Sunset Ridge – Agenda Item #22

Commission Meeting Presentation

July 23, 2024

Incursion of Sunset Ridge Residents on Travis County West

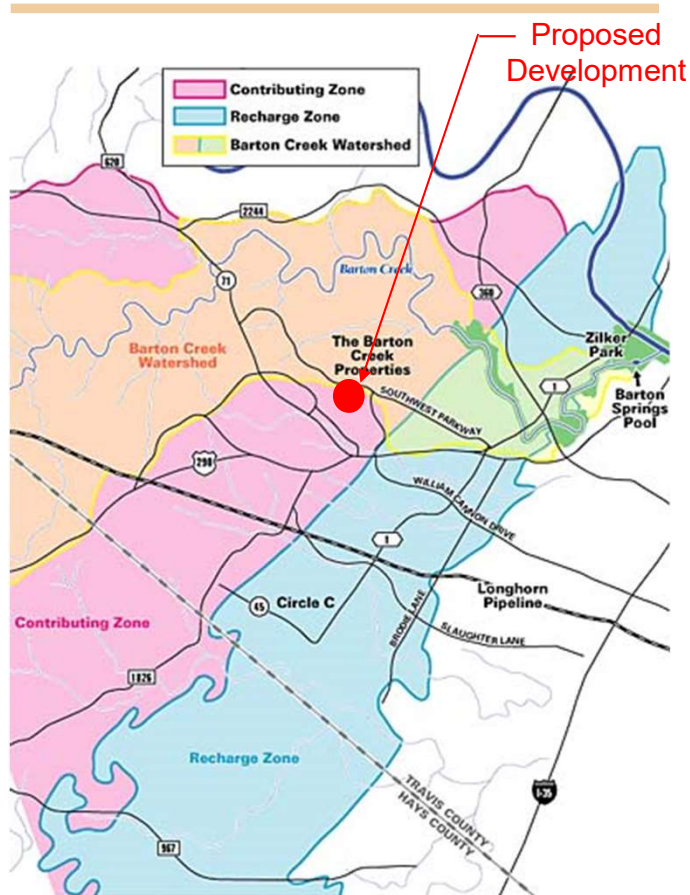
- Proposed site plan indicates vehicular access to Sunset Ridge will be prohibited except for emergency access
- **Pedestrian access is not explicitly prohibited**
- A 440+ unit development will result in ~**1,300+ additional pedestrians trespassing** on Travis County West green spaces, amenity center, playscapes, & trails
- Travis County West residents pay HOA dues to maintain these amenities, they are not publicly funded parks
- Limited road shoulders and narrow roadways pose an unacceptable pedestrian safety risk and incursion into an established community
- **Development should be reduced in scope and REQUIRE private parkland, not a “fee-in-lieu”**
- **Should require perimeter fencing and crash gate prohibiting pedestrian access to private land**

Site Plan Must Comply with 25% Impervious Cover Limit

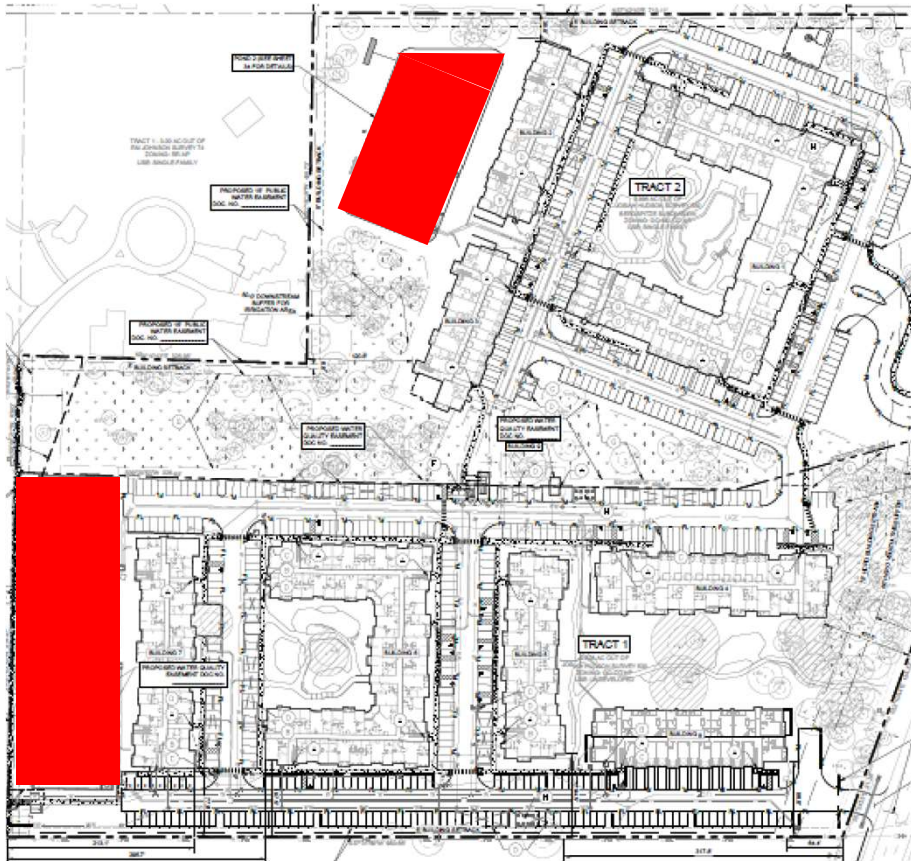
- The tract is subject to a 25% impervious cover limit based on Net Site Area (NSA) as per the current Save Our Springs Ordinance (Ordinance No. 19920903-D)
- No basis for grandfathering as no project was permitted prior to the enactment of the Save Our Springs Ordinance
- The original restrictive covenant was not required and entered into by the parties voluntarily
- An applicable legal precedent has been provided to the City supporting the applicability of the Save Our Springs Ordinance
- Requested an appeal on the vesting rights, but was denied
- Any site development needs to comply with all current applicable laws and regulations including the Save Our Springs Ordinance
